This is to certify that AVESTA HOUSING

Job ID: 2012-07-4379-NEWCOM

From: "Val Paquin-Gould" <vpaquingould@greatfallsinc.com>
To: <jmb@portlandmaine.gov>
Date: 7/31/2012 8:27 AM
Subject: ADAMS - Plan Review Response - 07/30/12
CC: <regan@greatfallsinc.com>, <darren@greatfallsinc.com>
Attachments: Bldg_Response_Ltr_073012.pdf; CodeReview.pdf; window_door_schedule.pdf; A105.pdf

DATE: 07.30.2012
TO/COMPANY: Jeanie Bourke
CEO/LPI/Plan Reviewer
City of Portland
Planning & Urban Development Dept. / Inspections Division
PROJECT: Adams School Condominiums
FROM: Kathy Cogan Kahill
PAGES:
RE: Code Review of BP# 2012-07-4379

② Copy of WINDOW TYPES
1/4" = 1'-0"

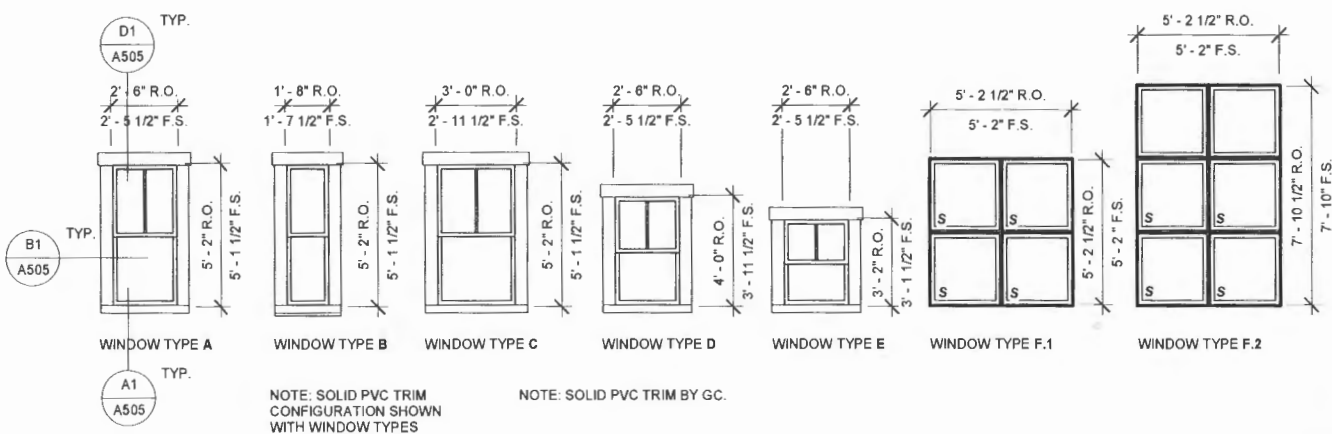
9. A-500, provide a detail of C55 wall type at dwelling unit stair stringer framing. Detail will be provided under separate cover.
10. Provide a window schedule including tempered / safety glazing locations per Sec. 2406. For all double-hung window types, sill height is a minimum of +18" above finished floor. All glazing in swinging doors shall be safety glazing. All storm door glazing shall be safety glazing. All glazing in window type F.1 shall be safety glazing. Glazing in the bottom four units of window type F.2 shall be safety glazing.

S - DENOTES SAFETY GLAZING IN ACCORDANCE WITH IBC 2009 SECTION 2406

JOB NO.
06-056
DRWN: CHK
D.S.B.
SCALE:
As Indicated
ISSUE
03/05/12
TITLE
FOUNDATION
PLAN PART 2
SHEET
S1.2

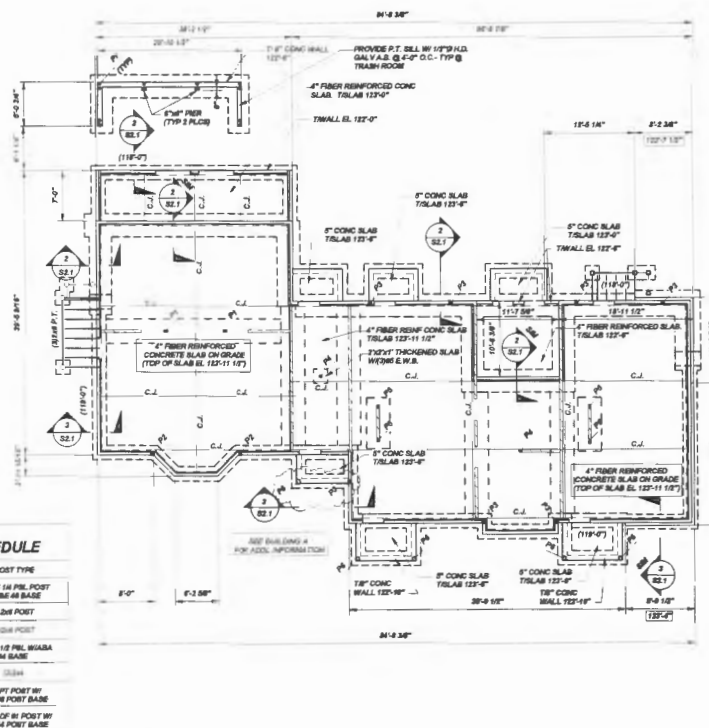
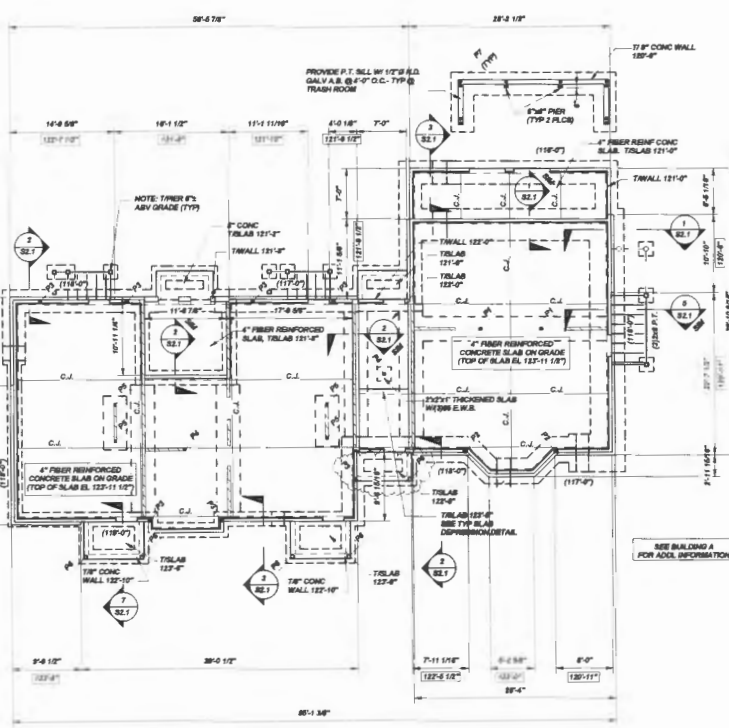
- Sheet S1.1: MODIFY as shown on attached S1.1/Addendum 2.
Sheet S1.2: MODIFY as shown on attached S1.2/Addendum 2.
Sheet S1.3: MODIFY as shown on attached S1.3/Addendum 2.

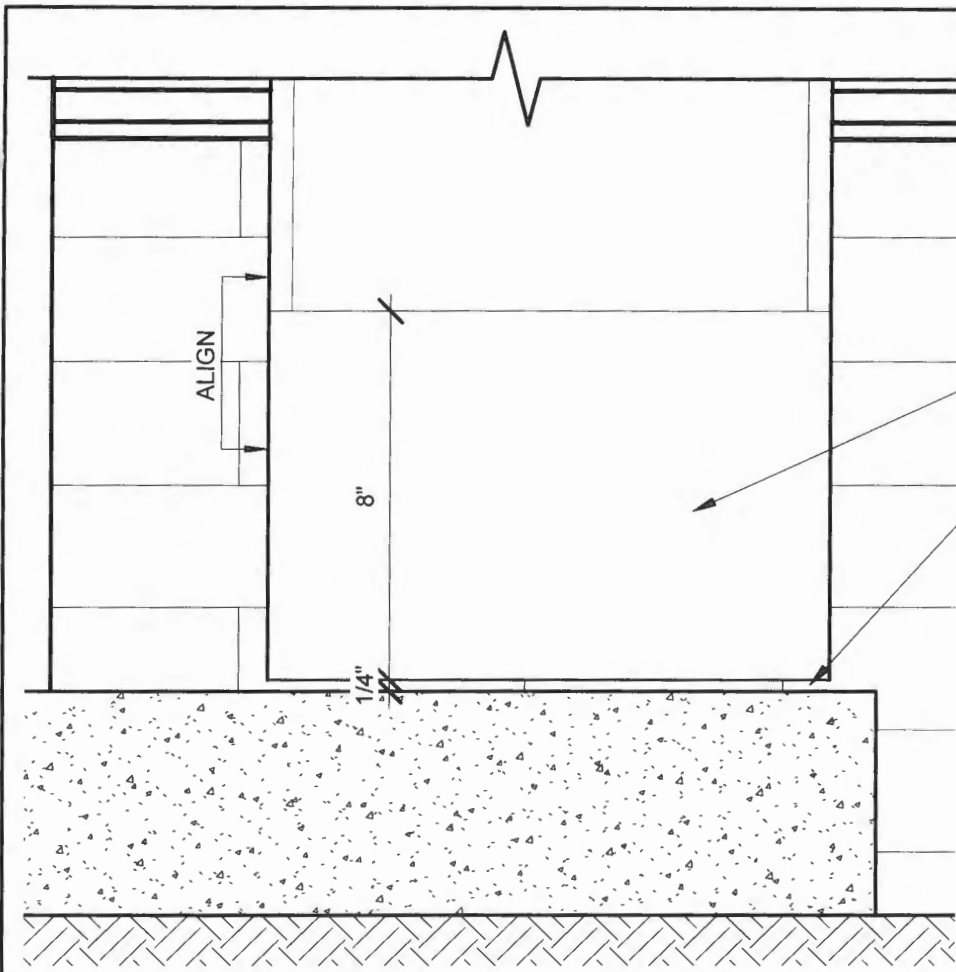
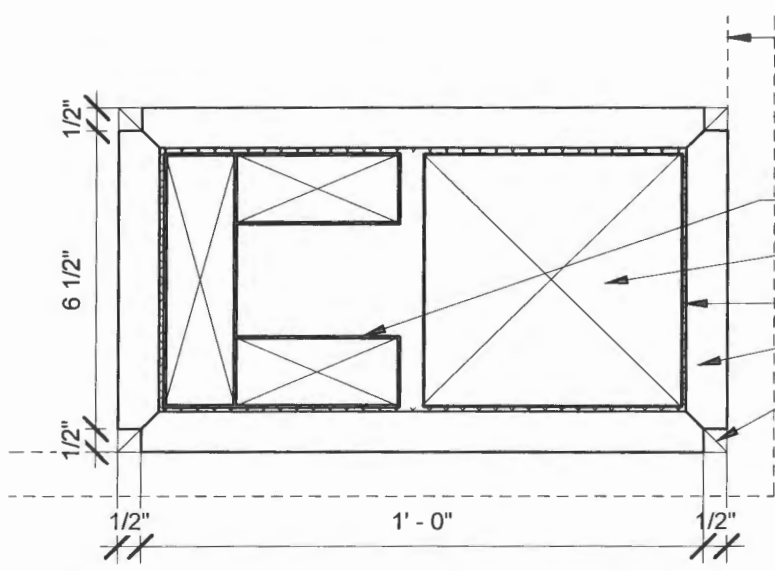
- A. ADD detail SKA-1/Addendum 3 for post wrap at Entry Canopies.

A. Sheet E100 Site Drawing

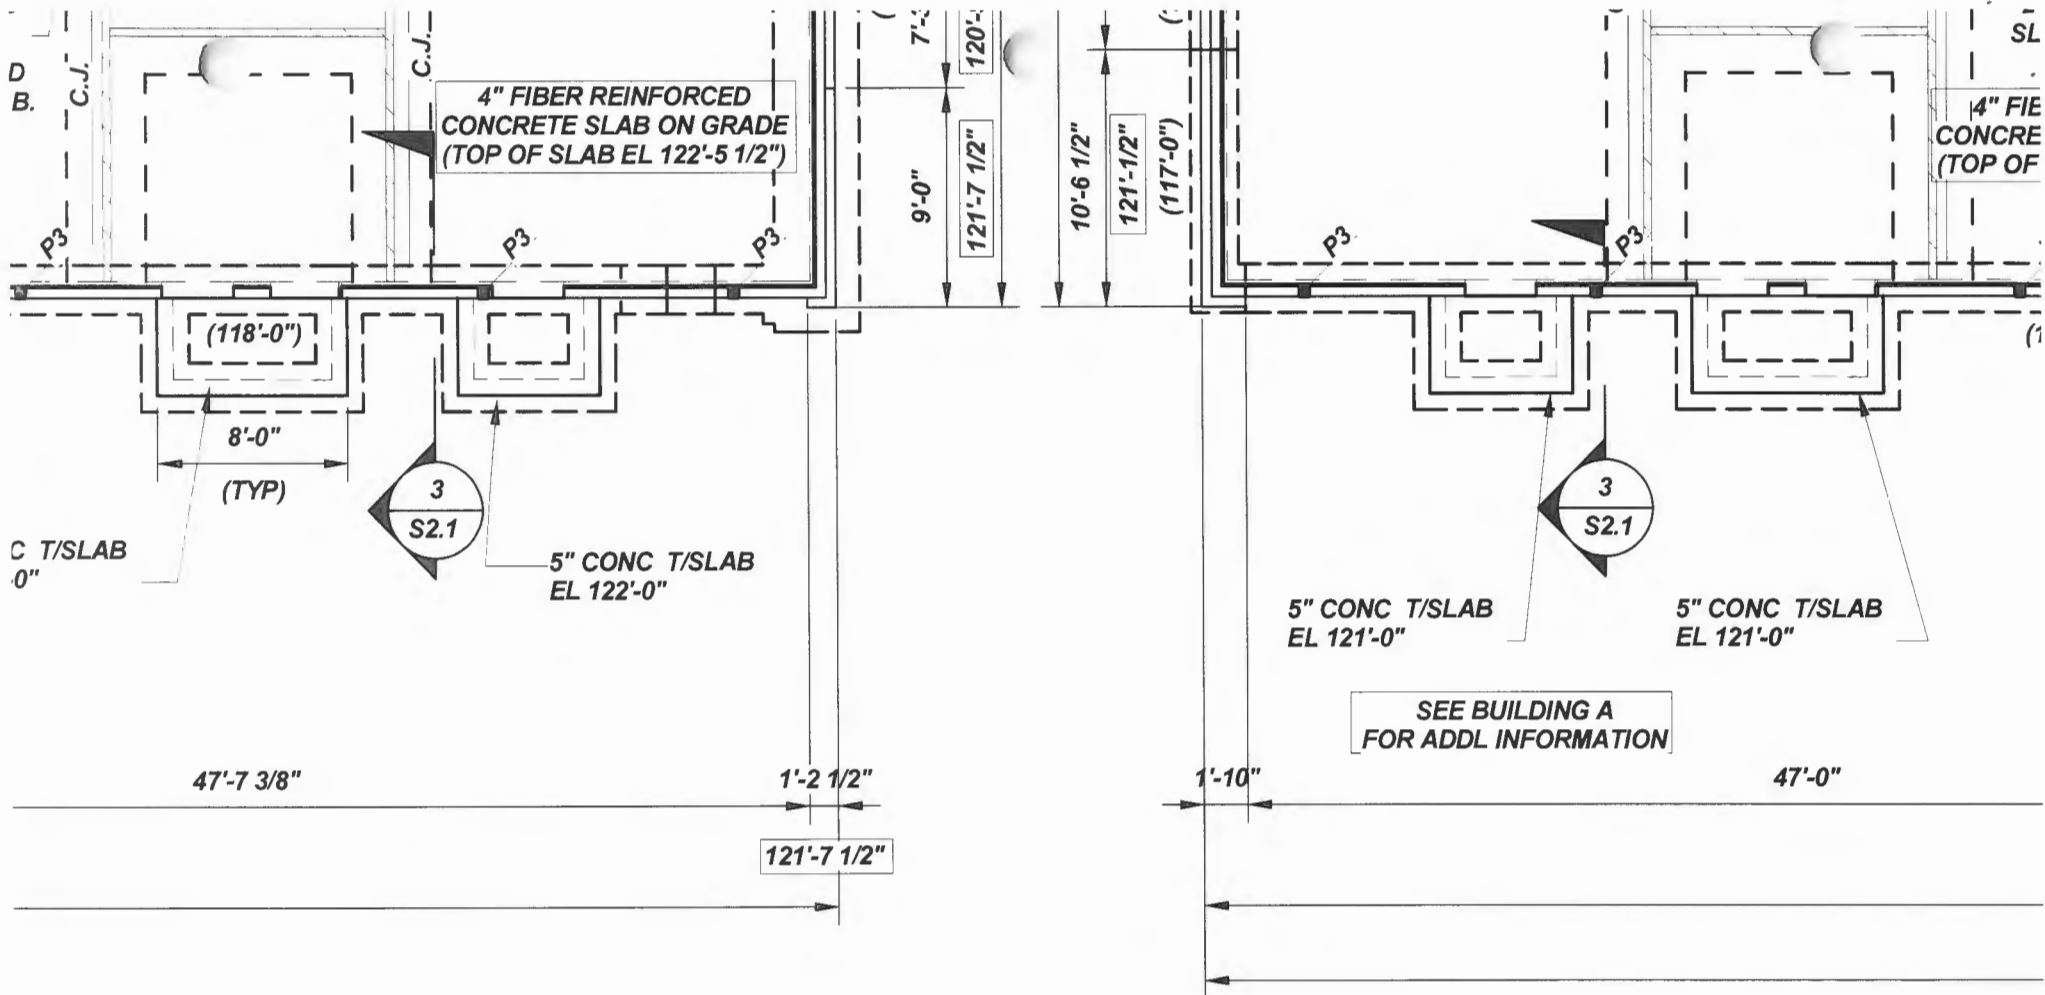
Contractor shall provide surge protection on underground fire alarm cables run between buildings.

Contractor shall install one FA pull station in each sprinkler room qty (4).

SHEET
 SKA-2

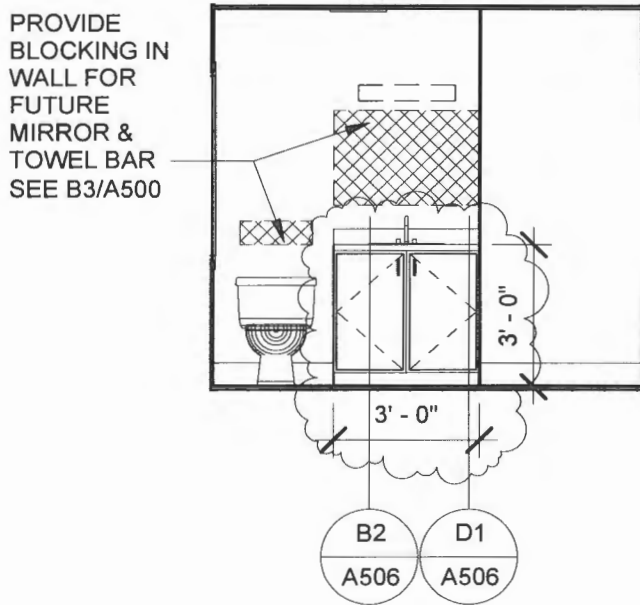
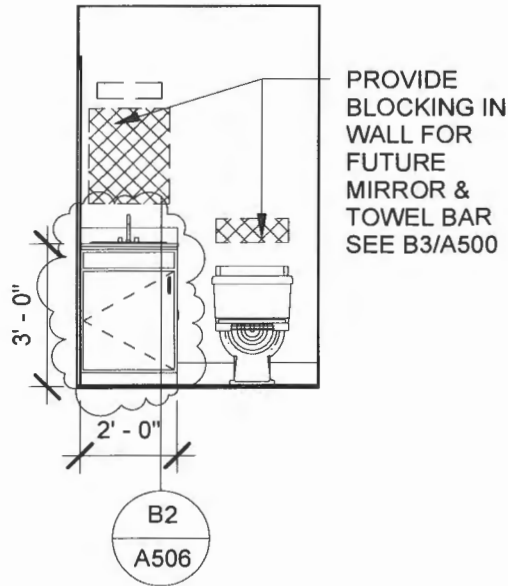
- A. Sheet A202: Modify interior elevations as shown in attached sketches SKA-2-SKA-6/Addendum 5.
- B. Detail 1/A503: CHANGE title from "Ice Dam" to "Ice Belt."
- C. Detail A2/A504: ADD note "2x12 wood stringers, typical."
- D. Detail B1/A504: ADD note "2x12 wood stringers, typical."
- E. Detail C1/A504: ADD note "2x12 wood stringers, typical."
